**DRAFT BCA/NCC Compliance assessment of the plans for the proposed
(3) Storey Residential, Retail and associated Basement carparking
Building at 1 Bilambree Ave Bilgola Plateau NSW**

Drawn by Benson McCormack Architecture, Project No.2012A, Rev B

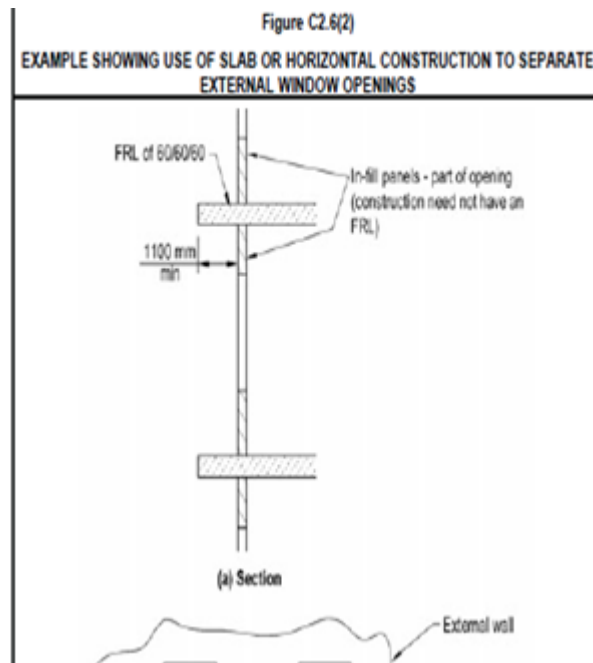
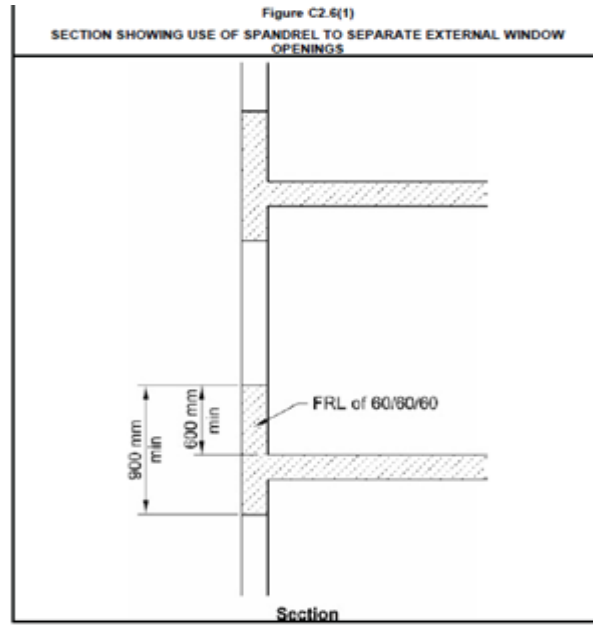
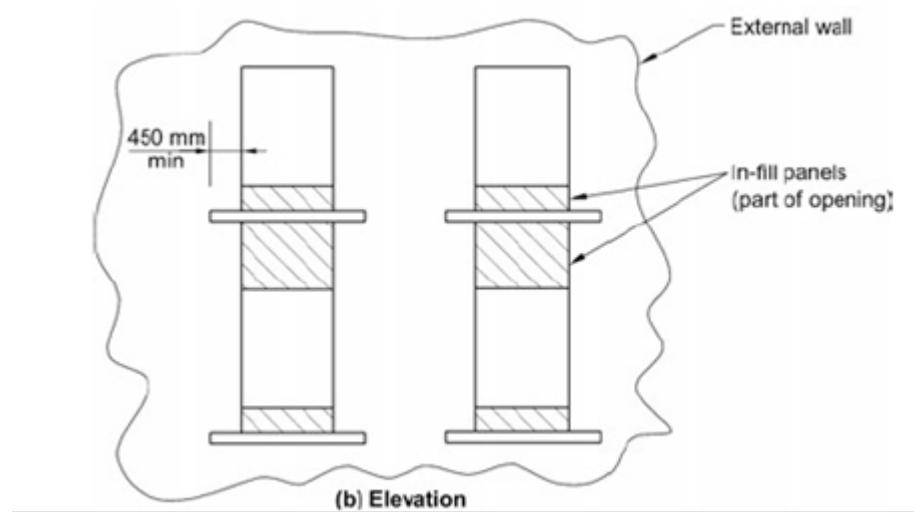
From looking at the elevations, the building appears to have openings above openings which will require separation/ protection in accordance with one of the below methods, architect is to provide further details and notations as to DTS method adopted on CC issue plans for FRL's of the external part of wall where non-loadbearing

The balconies will require 450mm extension beyond openings per below diagrams, the architect will need design the below requirements accordingly into the building

- (A) is not less than 900 mm in height; and
- (B) extends not less than 600 mm above the upper surface of the intervening floor; and
- (C) is of non-combustible material having an FRL of not less than 60/60/60

- (A) Projects outwards from the external face of the wall not less than 1100mm and extends along the wall not less than 450mm beyond openings concerned and is non-combustible achieving an FRL of 60/60/60
